<b>Subject:</b>  REAR CONSOLE LID IS LOOSE	<b>Bulletin No:</b> 09-023/15
	<b>Last Issued:</b> 12/14/2015

## BULLETIN NOTE

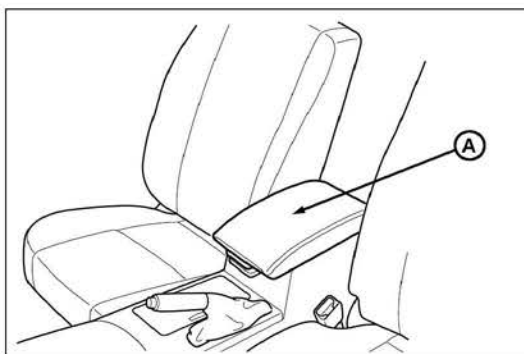
Some customers may complain about a loose rear console lid (A).

This may be caused by hinge pins coming partially off (B) or completely off.

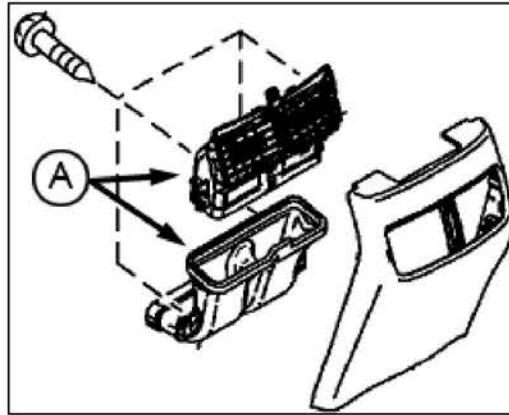
**NOTE:** The shape of the rear console panel has been changed, by adding a stopper rib to prevent the pin from coming off.

4. **Mazda3 and Mazda6 without ventilation**, install a new rear console panel. (See PART(S) INFORMATION)
